Detailed Site Plan Gilpin Property, Phase III

DSP-13008-02

STAFF REPORT

SUBJECT: Detailed Site Plan DSP-13008-02
 Type 2 Tree Conservation Plan TCP2-018-13-02
 Gilpin Property, Phase III

Figure 1: Illustrative Site Plan

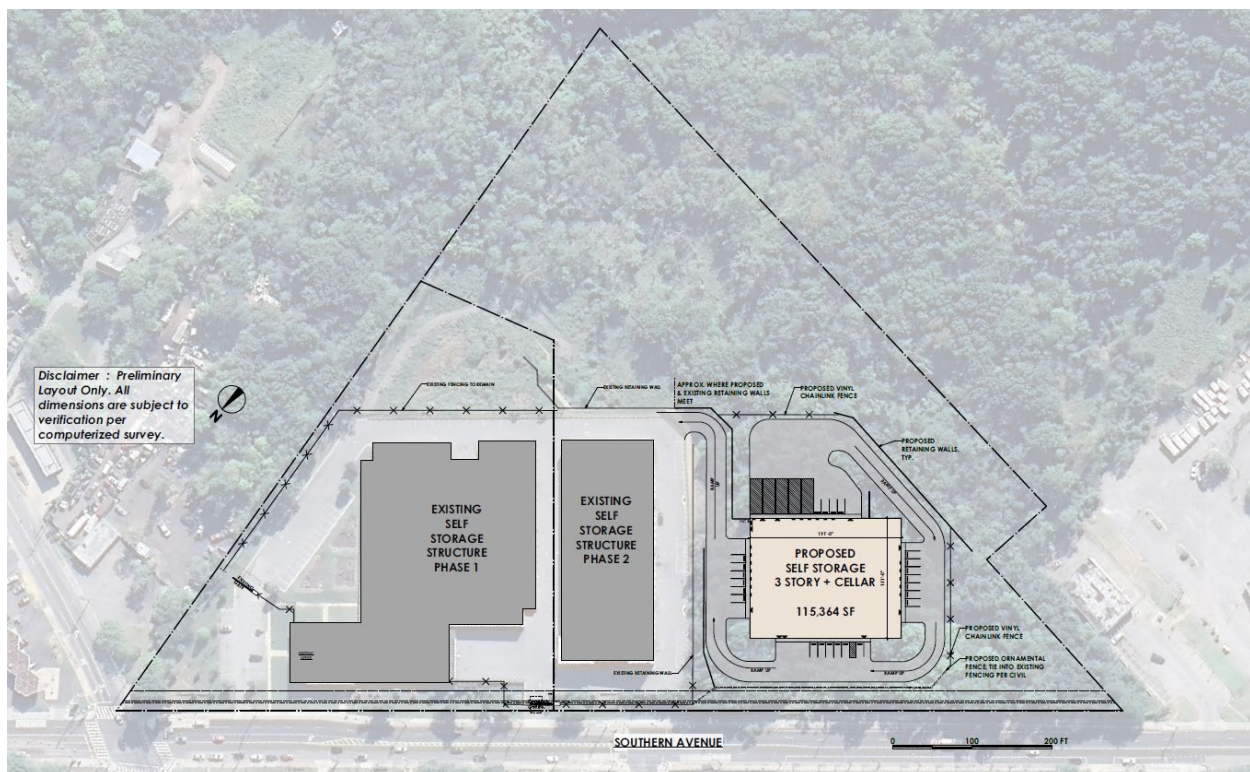
The overall site has one proposed entry/exit point along Southern Avenue. Two truck turning exhibits were also provided to demonstrate the ability for large vehicles to maneuver through the site. Sidewalks are proposed adjacent to all entrances. Given the topography of the site, sidewalks are not continuous, and given the unique characteristics of the site, it is not possible to provide a continuous pedestrian route along the proposed building. All

proposed parking spaces are located along the perimeter of the building, allowing easy use for loading and unloading, while also alleviating the need for pedestrians to cross parking lanes.
